# Landscape and visual note on proposed site at Leek Road – HPK/2017/0110

## Purpose of note

To give a summary of the Site visit made by Stuart Ryder of Ryder Landscape Consultants on behalf of the development control team of High Peak Borough Council (HPBC). It captures the observations of Site and the surrounding area with regard to landscape and visual matters to inform the development control team considering the current planning application by Persimmon Homes (North West) for a residential development at this site.

The below extract from the Proposals Plans shows the designations around the site.

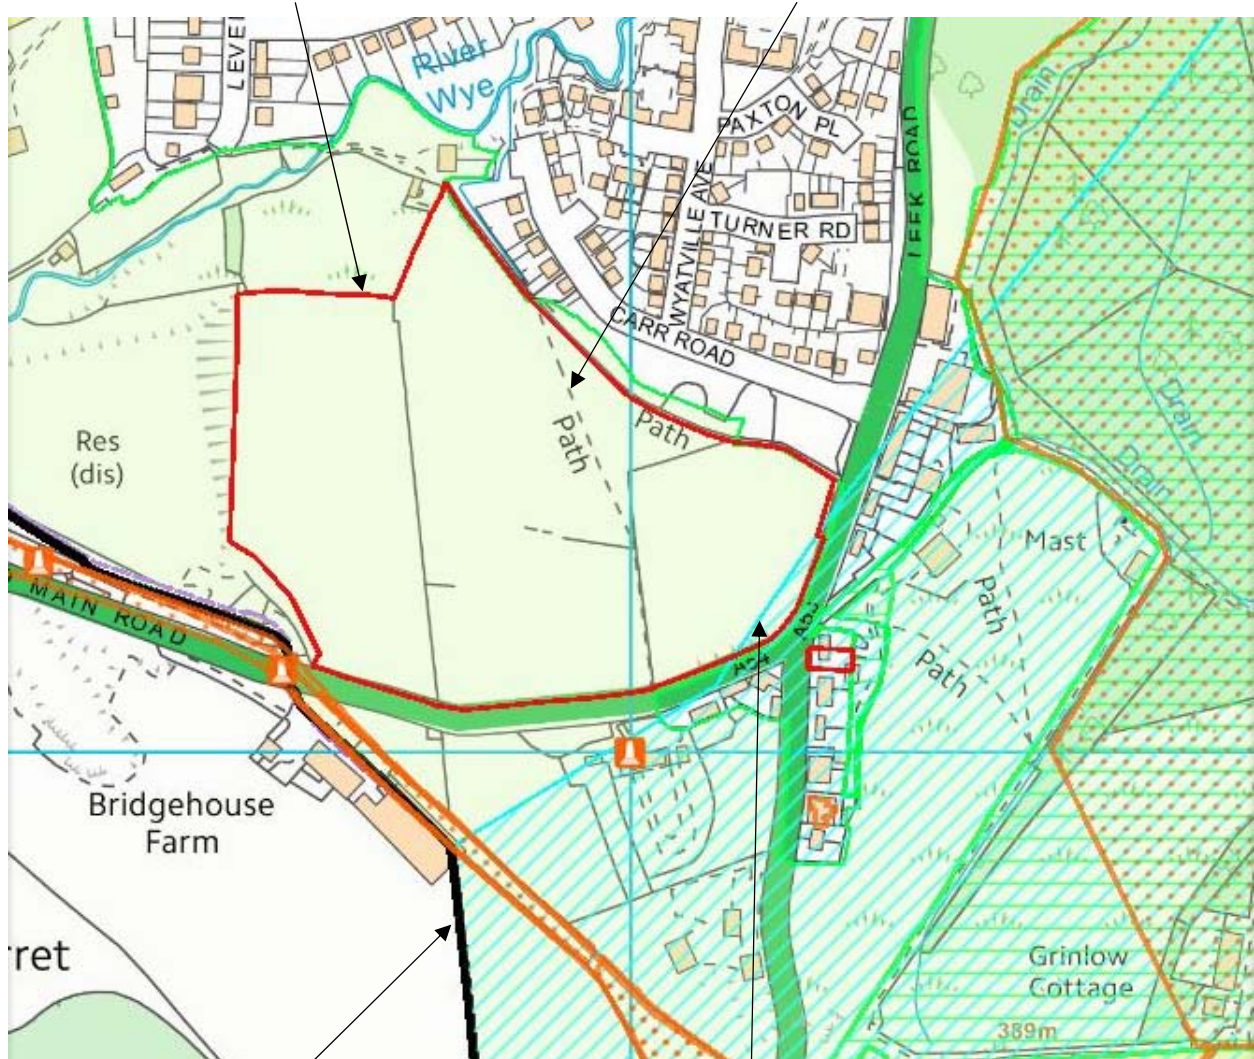
The site on the HPBC Proposals Plan 2016 is considered to be countryside and a small part at the south east corner falls within the Buxton Mineral Water Catchment.
